SUNDRY NOTICES AND REPORTS ON WELLS (DO NOT USE THIS FORM FOR PROPOSALS TO DRILL OR TO DEEPEN OR PLUG BACK TO A DIFFERENT RESERVOIR. USE "APPLICATION FOR PERMIT" (FORM C-101) FOR SUCH PROPOSALS.)		WELL API NO. 30-025-01271
1. Type of Well: Oil Well Gas Well Other SWD		5. Indicate Type of Lease STATE X FEE
2. Name of Operator TLT SWD, Inc		6. State Oil & Gas Lease No.
3. Address of Operator PO Box 1906, Hobbs, NM 88241		7. Lease Name or Unit Agreement Name Phillips State
4. Well Location Unit Letter <u>I</u> : <u>1980</u> feet from the <u>South</u> line and <u>660</u> feet from the <u>East</u> line Section <u>25</u> Township <u>16S</u> Range <u>33E</u> NMPM Lea County		8. Well Number 001
11. Elevation (Show whether DR, RKB, RT, GR, etc.)		9. OGRID Number 287481
10. Pool name or Wildcat Kemnitz; Lower Wolfcamp

Proposed Plugging Procedures

Phillips State # 1

**CONDITIONS OF APPROVAL
FOR PLUGGING AND ABANDONMENT
OCD - Southern District**

Proposed
Atty Plugging

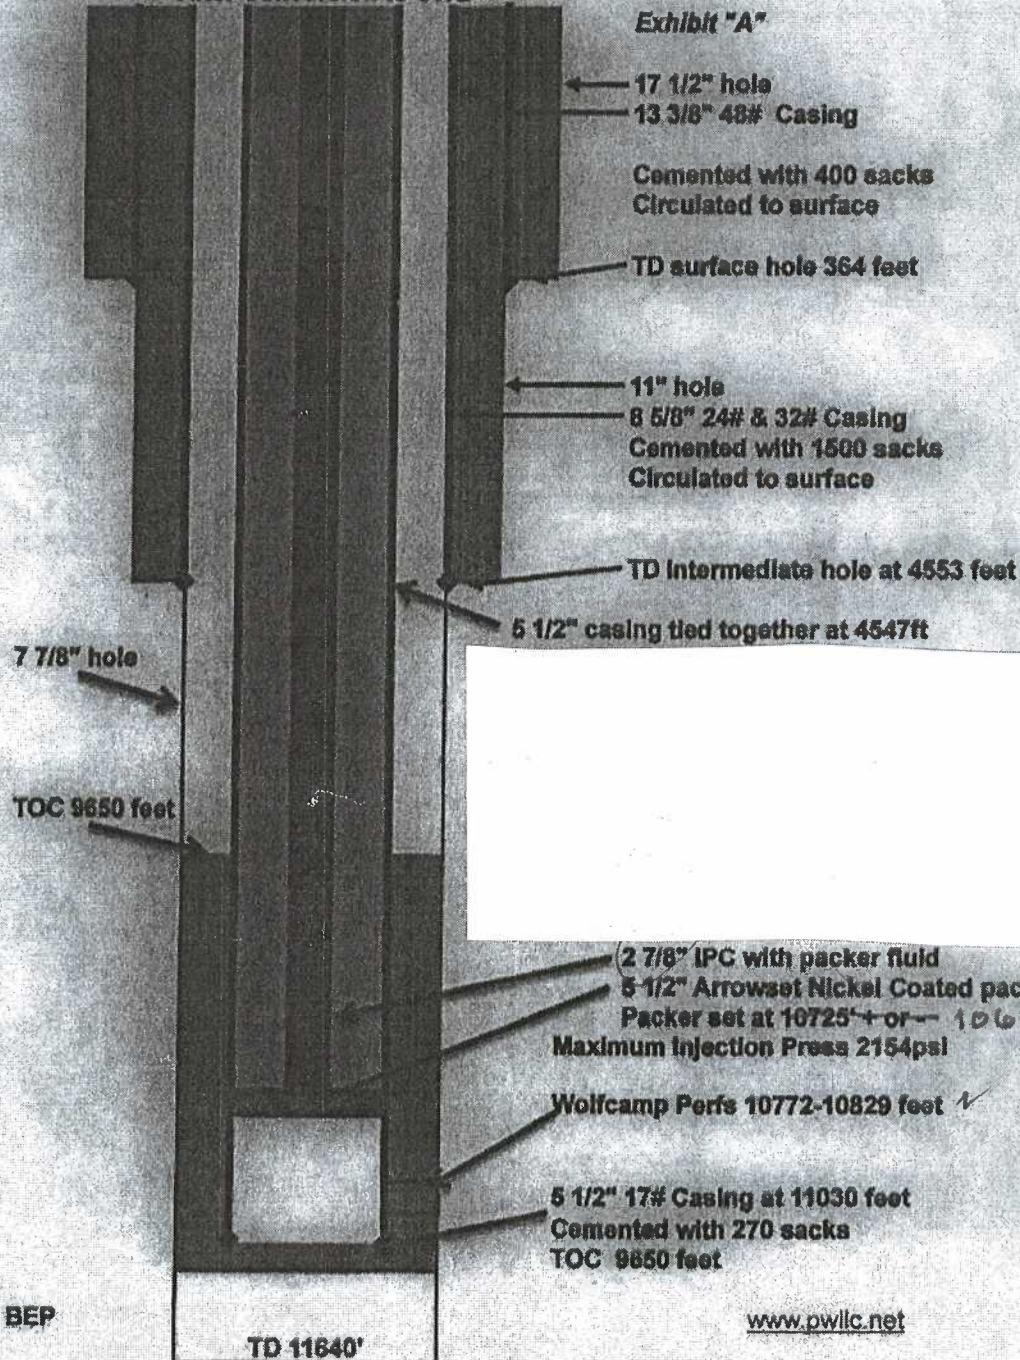
4" diameter 4' tall above ground marker
